Product Recall

Subject: RECALL 08V-356 – Power Cable Routing

RECALL #08V-356
INSTRUCTION SHEET #TBB 85490100

SUBJECT: POWER CABLE ROUTING

Figure 1

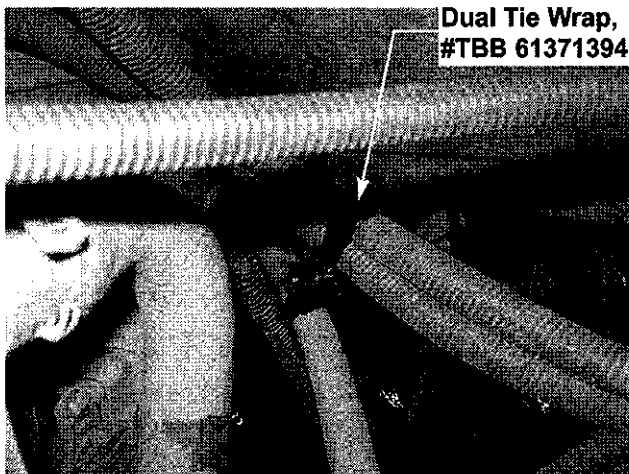
1. Disconnect battery cables from batteries.
2. To inspect wiring, cut any existing zip ties from electrical box on right side of engine compartment to the alternator, and the relay for intake heater. These are two red 2ga. wires.
3. Inspect wire loom for damage in these areas. **Figure 1**

Inspect this area for damaged loom.

- 3.1 If damage to the wire loom exists, continue to step 4.
- 3.2 If no damage to wire loom exists, skip to step 8.
4. Partially remove existing wire loom at area of contact with fuel line.

Figure 2

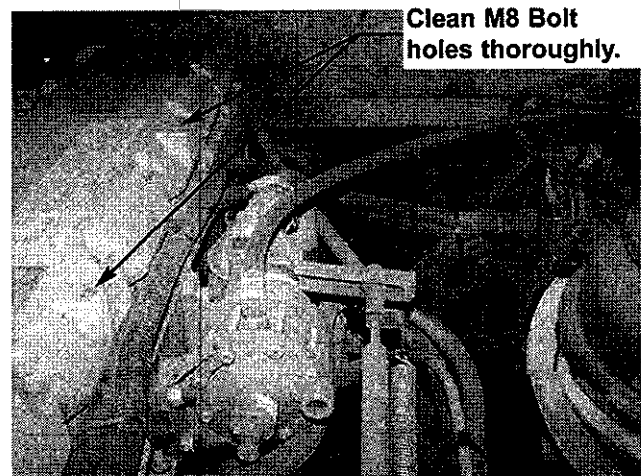
8. If no damaged to the copper strands is found, install Dual Tie Wrap, #TBB 61371394 to secure cable and fuel line. **MAKE SURE THEY DO NOT TOUCH. Figure 2**

Figure 3

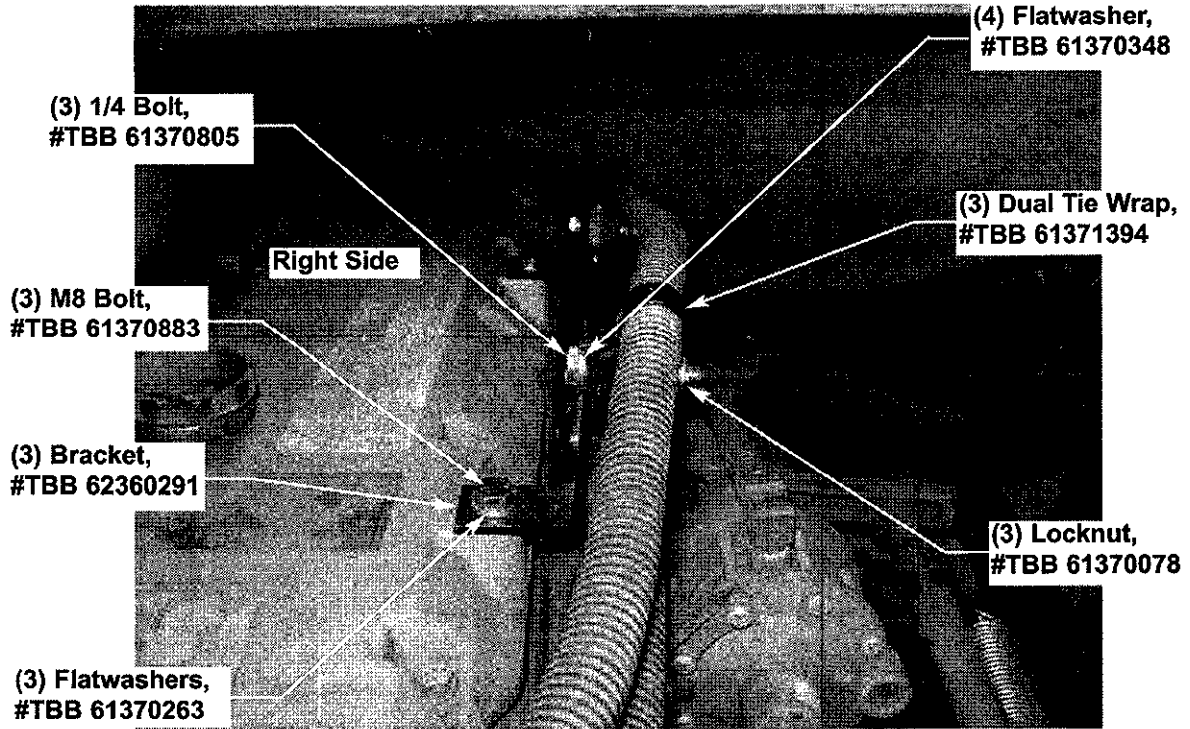
9. Locate and clean the two M8 bolt holes on the top right side of the valve cover as shown in **Figure 3**. Using brake cleaner and a screwdriver, clean the bolt holes thoroughly of all debris before proceeding.
